The Commission has issued the enclosed Amendment No. 31 to Facility Operating License No. DPR-74 for the Donald C. Cook Nuclear Plant, Unit No. 2. The amendment consists of changes to the Technical Specifications in response to your application transmitted by letter dated May 1, 1981 as supplemented by letter dated May 7, 1981.

This amendment revises the Axial Power Distribution Monitoring System (APDMS) technical specifications and the setpoint for the P-7 permissive (interlock).

Amendment No. 31
License No. DPR-74

AMENDMENT NO. 31 TO FACILITY OPERATING LICENSE NO. DPR-74

FIGURE 3.2-1 AXIAL FLUX DIFFERENCE LIMITS AS A FUNCTION OF RATED THERMAL POWER

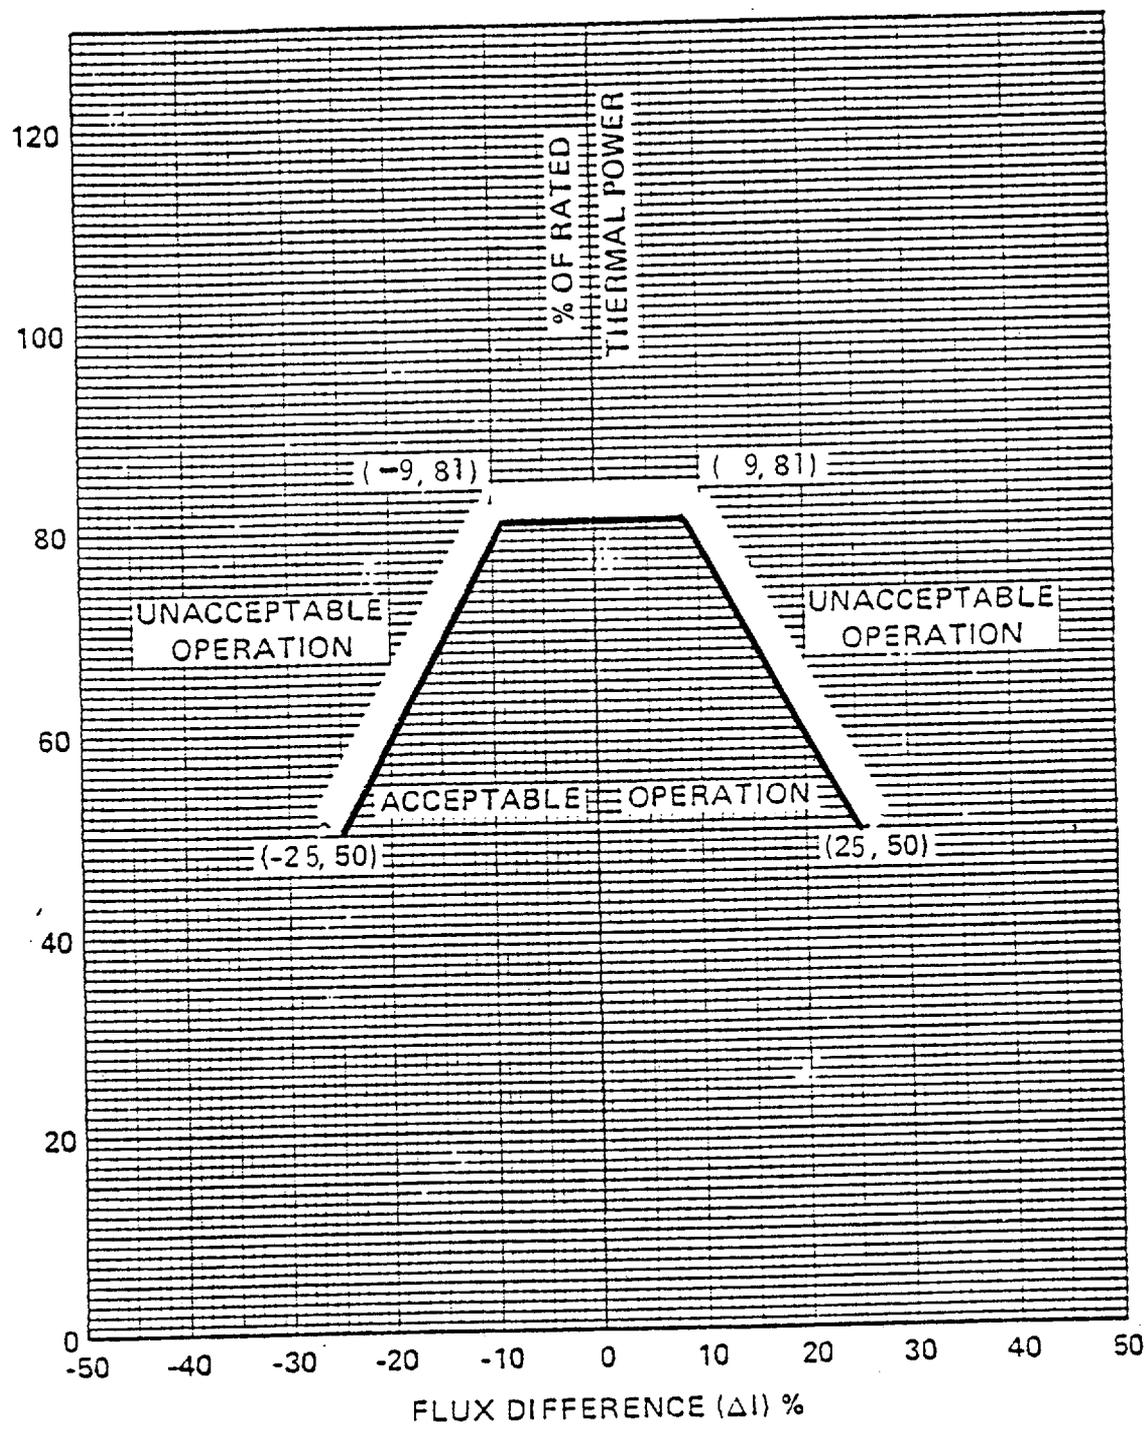
Because of the reduced APDMS turn on point, the axial flux difference limits as a function of thermal power are also changed. We have reviewed the change as well as the APDMS turn on point and find them satisfactory.

- 2) The indicated AFD is within the limits shown on Figure 3.2-1. Otherwise, reduce THERMAL POWER to less than 50% of RATED THERMAL POWER within 30 minutes and reduce the Power Range Neutron Flux-High Trip Setpoints to ≤ 55% of RATED THERMAL POWER within the next 4 hours.
